IOWA DEPARTMENT OF TRANSPORTATION

To Office Bridges and Structures Date December 1, 2007
Attention All Employees Ref No. 521.1
From Gary Novey
Office Bridges and Structures
Subject Revision to J24-06, J30-06, J40-06, J44-06 Continuous Concrete Slab Bridge Standards.
CADD M0091

1. J24-01-06, J30-01-06, J40-01-06, J44-01-06

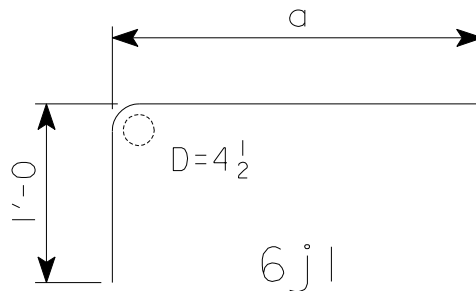
The following “Designer Notes and Design Considerations” was changed for allowable depth to rock. The updated note reads as follows:

IF ROCK IS ENCOUNTERED LESS THAN 5 FOOT BELOW THE PREBORED HOLES, A SPECIAL ANALYSIS WILL BE REQUIRED. WHEN PREBORING IS NOT REQUIRED FOR THE ABUTMENT FOOTING AND ROCK IS ENCOUNTERED LESS THAN 10 FOOT BELOW THE BOTTOM OF ABUTMENT FOOTING A SPECIAL ANALYSIS WILL BE REQUIRED.
